# Newmar Corporation Warranty Department

## Technical Service Bulletin

TSB 363

**Subject:** Ground wire sizing for electric leveling jacks.

Figure 2

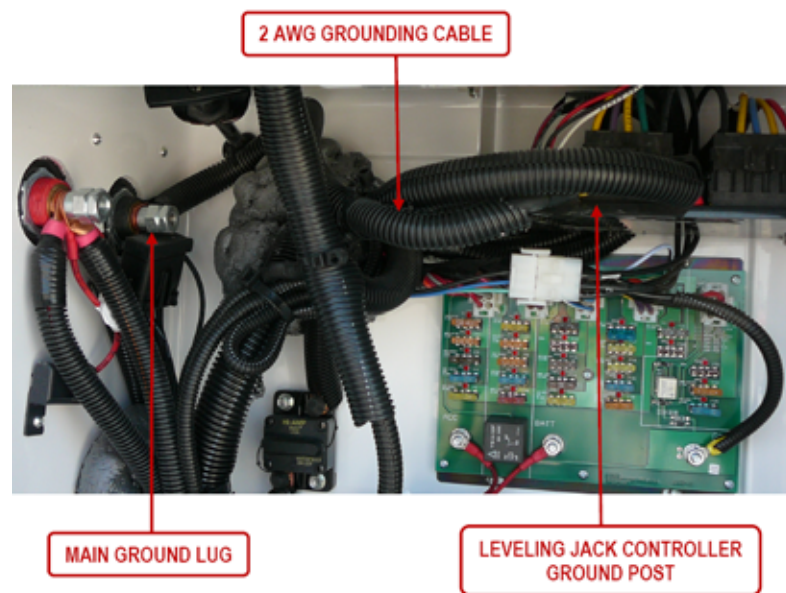
**Condition:** The ground wire for the electric leveling jack system is undersized. Undersized electrical conductors may result in conductor failure, creating a shock or fire hazard. Failure of the cable may occur without obvious preceding indicators.

**Description:** Units identified with an undersized(1) grounding wire for the electric jacks should add a properly sized grounding cable. The removal of the undersized cable is not required or necessary.

- Measure length of 2 AWG cable required and cut to length. Strip cable ends and crimp ring terminals to cable.
- Attach small ring terminal of 2 AWG grounding cable to the ground post of the leveling jack controller (Figure 2) and large ring terminal to the main ground lug.
- Reset leveling jack controller per instructions in the owner's manual.

*Note 1: The existing 10 AWG ground cable connected to leveling jack controller ground post does not need to be removed.*

*Note 2: Torque conductive nut on the controller ground post to 20 – 20 in/lbs. Torque conductive nut on the main ground lug to 6 – 8 ft/lbs.*
